THE KEYSTONE

Drawings & Diagrams

October 19, 2015

Summary of HPC Coordination (9/12/15)

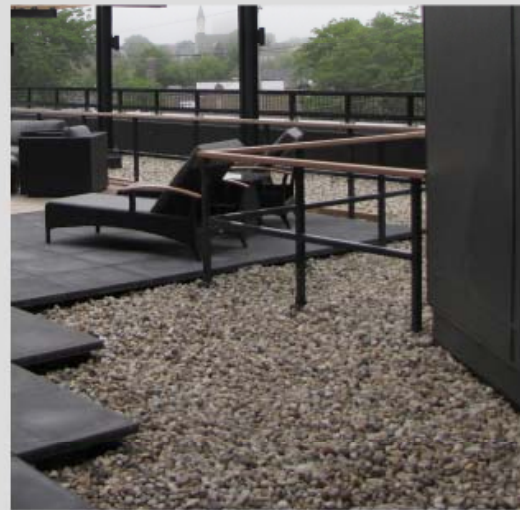
8. Provide details of exterior vents including individual HVAC units and garage ventilation system.

EA Response: See pictures of product, we will try to conceal these under balconies or at return walls as much as code will permit. The product is an anodized aluminum wall cap.
